UNITED STATES
NUCLEAR REGULATORY COMMISSION

November 8, 1996

FACILITY: Sequoyah Nuclear Plant, Units 1 and 2

SUBJECT: SUMMARY - NOVEMBER 4, 1996, MEETING WITH TVA TO BRIEF THE STAFF ON
THE STATUS OF THERMO-LAG FIRE BARRIER UPGRADES AT SEQUOYAH

Issue Number One

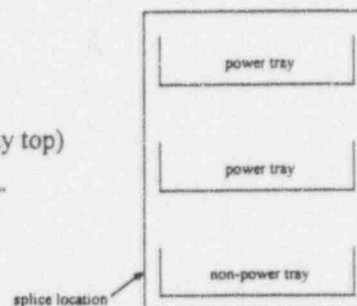
Confirm absence of tray cover on specimen 7.1 baseline

- Testing of an open tray confirmed in four sections of the report
 - Test plan
 - Sequence and Procedure
 - List of test configurations
 - Description of test articles
 - Photographs
